Authors' responses to the editor's comment:

Authors' responses to the reviewer's comments:

Figure 1: Convergence test done for (i) temperature from 300 K to 83 K by step of 20 K and (ii) capture cross section ($\sigma_n \rightarrow 0$) from $1 \times 10^{-16} \text{ cm}^2$ to $1 \times 10^{-31} \text{ cm}^2$ by step of 10^{-3} .

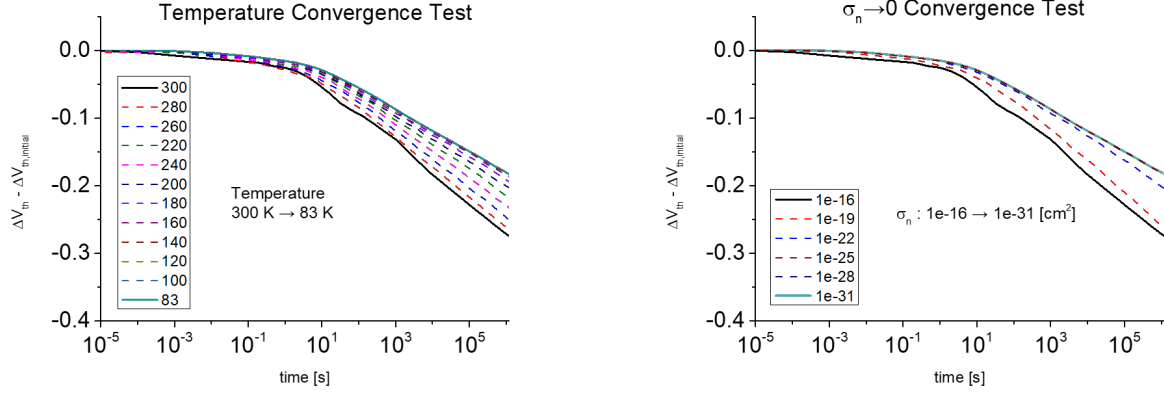
The manuscript states that direct TCAD simulation at 4.2K did not converge and that the electron capture cross section was therefore reduced to an extremely low value during retention to emulate cryogenic operation. However, lowering the temperature to 4.2K should affect not only the capture cross-section but also carrier distribution, fermi occupation, thermal velocity, emission/capture balance, and field-assisted transport parameters. Could the authors justify why only reducing σ_n is sufficient to represent cryogenic retention? If the change in other parameters was also included, please adequately explain it. Please also provide a sensitivity analysis showing whether the retention transient saturates as σ_n is reduced.

We thank the reviewer for this important comment. We agree that reducing only σ_n does not reproduce all temperature-dependent physical quantities at 4.2 K, such as carrier statistics, thermal velocity, Fermi occupation, emission/capture balance, and field-assisted transport parameters. Therefore, in the revised manuscript, the reduced- σ_n condition is clarified as a cryogenic-emulation benchmark for suppressing thermally activated trap-to-conduction-band transitions, rather than as a full direct TCAD simulation at 4.2 K. To justify this treatment, we performed two independent convergence tests: (i) a temperature-lowering test and (ii) σ_n -lowering test.

In the temperature-lowering test, the TCAD temperature was reduced from 300 K to 83 K, which was the lowest temperature at which stable convergence was obtained in our setup. In the σ_n -lowering test, σ_n was reduced from 10^{-16} to 10^{-31} cm² in three-decade steps. As shown in response Figure 1, the retention transient converged to a limiting curve as σ_n was reduced, confirming that the selected low- σ_n condition is not an arbitrary fitting point.

The low- σ_n limiting curve also showed the same retention-time tendency as the independently obtained temperature-lowering trend. These results indicate that suppressing thermally activated trap transitions by reducing σ_n can reproduce the dominant cryogenic detrapping tendency within the convergent TCAD

framework. Accordingly, all TCAD results in Fig. 3 of the revised manuscript are described as calibrated cryogenic-emulation benchmarks, not as direct full-physics 4.2 K TCAD simulations.

Fig. 3(c): Comparison between the time-step-free simulation and the iterative refresh test for assessing the fixed-emission-rate approximation.

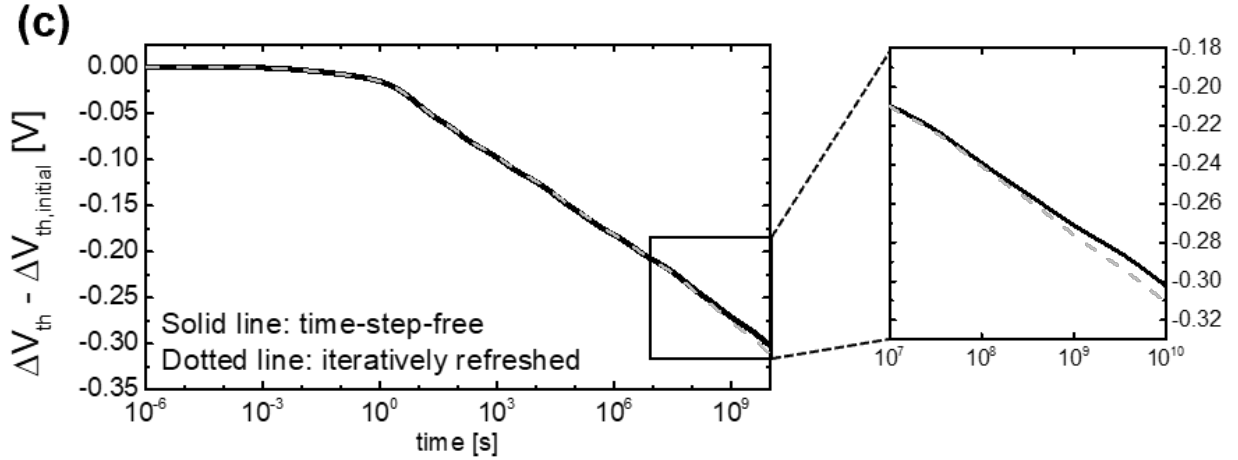
Does the time-step-free solution assume that e_{ch} and e_{WL} remain constant during retention? Considering that the trapped charge density, local potential, e -field, and tunneling barrier profile may change as

trapped electrons are emitted, emission rates can be modified. Could the authors provide a more detailed explanation and physical justification for treating the emission rates?

We thank the reviewer for raising this important modeling assumption. Yes, in the proposed time-step-free solution, e_{ch} and e_{WL} are evaluated from the initially programmed trapped-charge distribution and are treated as fixed during one closed-form retention evaluation. This fixed-emission-rate approximation makes the local detrapping equation autonomous and enables the closed-form solution in Eq. (13).

We agree that, in a fully self-consistent transient calculation, trapped-charge loss can modify the local potential, electric field, and tunneling barrier profile, and thus the emission rates can also be modified. To examine the error introduced by this approximation, we added Fig. 3(c), which compares the proposed time-step-free simulation with an iterative refresh test. In the iterative refresh test, the trapped-charge distribution is sequentially updated after each retention interval and then used as the initial condition for the next interval. Therefore, the refresh test partially accounts for the change in the electrostatic/barrier condition caused by the emitted charge.

As shown in Fig. 3(c), the time-step-free simulation and the iteratively refreshed simulation show nearly identical ΔV_T behavior over the retention range, with only about 3% difference appearing after times exceeding 10^9 s. This result indicates that the fixed-emission-rate approximation introduces only a minor error for the cryogenic radial detrapping benchmark considered in this work. Therefore, the non-iterative time-step-free simulation was selected as the main method because the iterative refresh test simply multiplies the simulation time by the total number of refresh iterations while producing almost the same retention result.

Figure 2: Convergence test done for (i) total trap bin # and (ii) CTN slice # showing good tendency of convergence from trap bin at 100 layers and CTN at 30 slices.

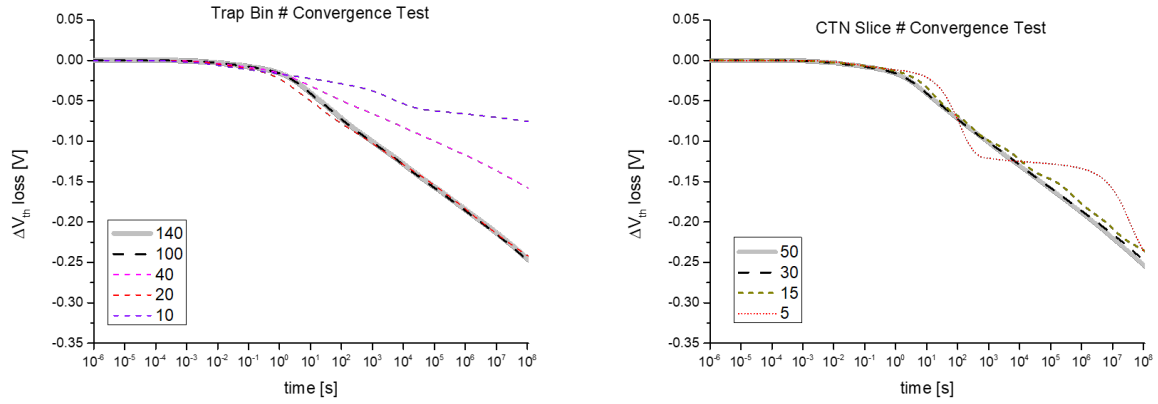
The model uses 100 trap-energy bins and 30 radial CTN slices. Could the authors provide a convergence test with respect to the number of energy bins and radial slices? Since the emission rate depends exponentially on trap energy and tunneling barrier shape, the predicted retention transient may be sensitive to discretization resolution.

We thank the reviewer for this constructive comment. We agree that discretization convergence should be checked because the emission rate depends sensitively on trap energy and tunneling barrier shape. We therefore performed convergence tests with respect to both the number of trap-energy bins and the number of radial CTN slices.

As shown in the additional convergence Figure 2 prepared for this response, the predicted retention transient becomes stable as the energy and radial discretization are refined. The result obtained with 100 trap-energy bins and 30 radial CTN slices is already in the converged regime for the benchmark condition

considered in this work. Further refinement produces negligible change in the retention transient while increasing the computational cost. Therefore, 100 energy bins and 30 radial CTN slices were selected as a numerically converged and computationally efficient discretization.

We revised the manuscript to state the discretization used in the model were confirmed to be in converged regime.
